Request for Decision

Application to extend draft approval of subdivision approval for a period of three years - St. Agnes Street & Brabant Street, Azilda - Cecchetto & Sons Ltd

File Number: 780-5/06004

DRAFT PLAN OF
PROPOSED SUBDIVISION ON
PART OF LOT 6
CONCESSION 1
GEOGRAPHIC TOWNSHIP OF RAYSIDE
CITY OF GREATER SUDBURY
DISTRICT OF SUDBURY
SCALE 1:5000
D.S. DORLAND LIMITED
ONTARIO LAND SURVEYORS
BAYSIDE ESTATES SUBDIVISION

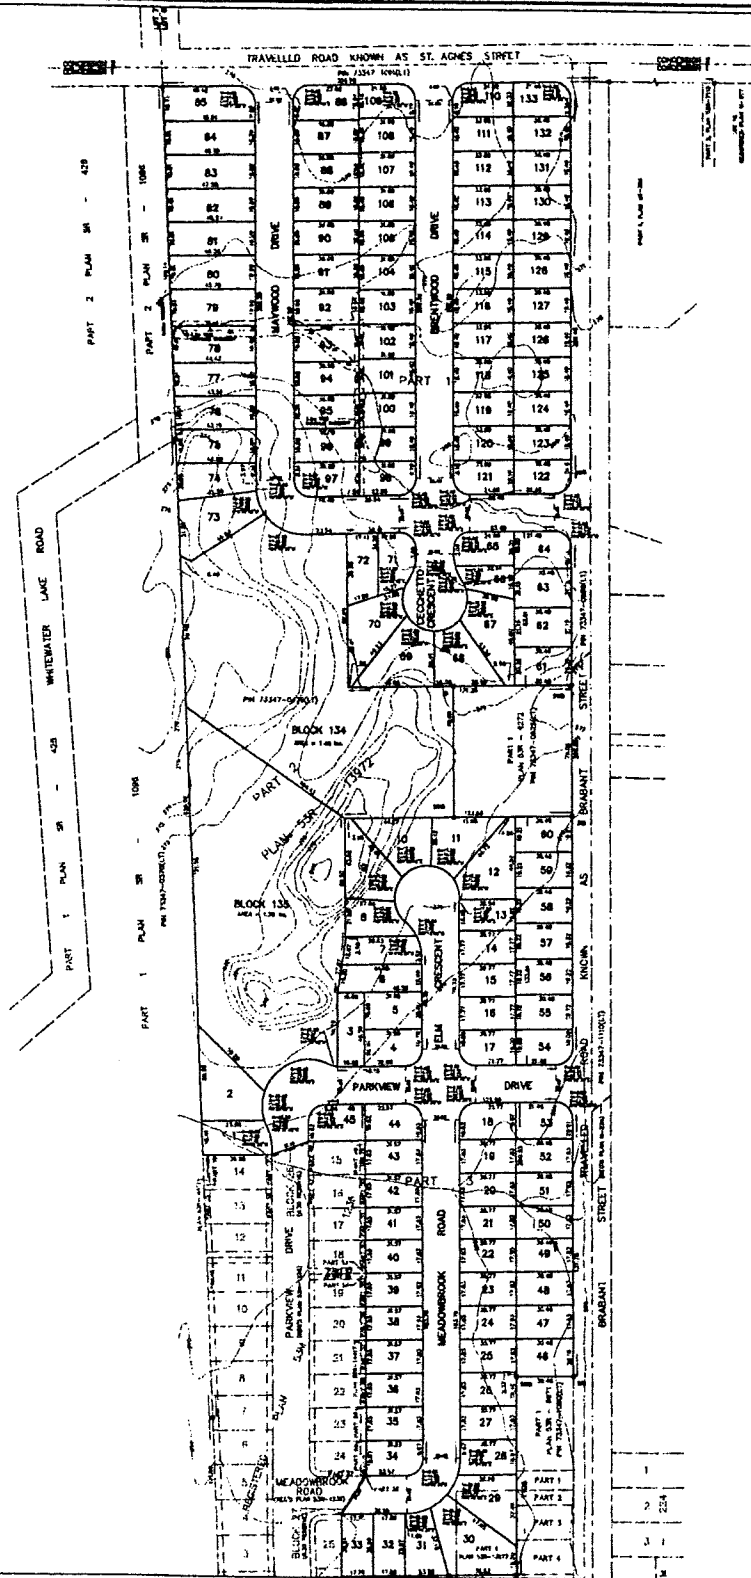
The Trillium Municipal Drain Branch A crosses through lots 78, 79, 92, 103, 102, 101, 100, 99, and 121 on the plan submitted for the subject property dated May 24, 2006. The City has future plans to upgrade the Trillium drain from Brabant Street to the lake outlet and to construct a communal storm water treatment facility downstream of the site. The existing Municipal Drain watercourse through the property is a major storm outlet watercourse and must be dealt with as such. Please amend the draft approval clauses by deleting Condition #13 and adding the following conditions:

"31. The existing Municipal Drain through the property must be enclosed in a box culvert with capacity to carry the 100 year storm for the upstream subwatershed and the applicable subject subdivision area.

32. The existing natural north-south watercourse through the centre of the north portion of the property has to be routed through a minor storm sewer system to the proposed box culvert with major storm flows directed overland along the proposed Brentwood Drive and Maywood Drive to outlet east of Brabant Street.

33. An 18 metre wide drainage block is required for the major storm box culvert and overflow swale near lots 78 and 79.

34. Quality and quantity storm water management is required for this subdivision. The Developer will be responsible for a cost share of a downstream storm water management quality control pond. The Regional Storm major storm flow path is to be engineered and delineated on the storm sewer area plan and the subdivision grading plan. Major storm overland flow for the subdivision is to remain within City road allowances and City drainage blocks.

35. The owner shall construct a 5 foot high chain link fence on the property lines of lots abutting City drainage blocks to curtail encroachment.

36. The owner shall construct a hydrodynamic oil grit separator for storm water quality control for the Brabant Street storm sewer outlet at the end of the Meadowbrook Road storm sewer system."
